NEWSLETTER

JULY 13TH 2016

SOFTWARE VERSION 2.3 - NEW FEATURES

INSTALLATION GUIDE R1C - NEW FEATURES

REDUCED TIGHTENING TORQUE

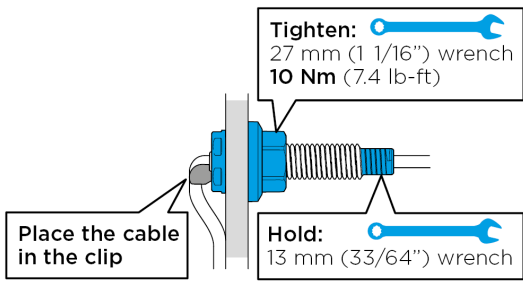
Thru-hull nut tightening torque reduced to 10Nm (1 kg on 1 m lever).

SERVO UNIT MOUNT BETTER DEPICTED

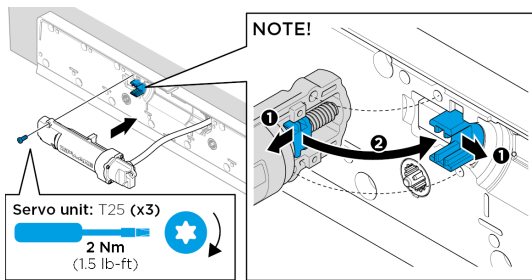
Concealed thru-hull fitting servo unit mount better depicted.

SYMBOL CLARIFYING TRANSOM SIDE

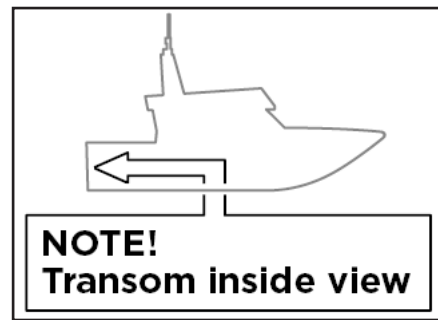
The wiring diagram now shows with a symbol the depicted side of the transom.

CONTROL PANEL - ANGLE RANGE

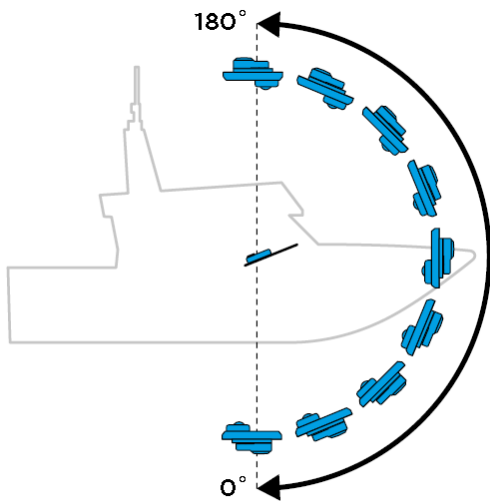
Control panel installation angle range increased and made less ambiguous.

NOTE! Any angle between 0-180°
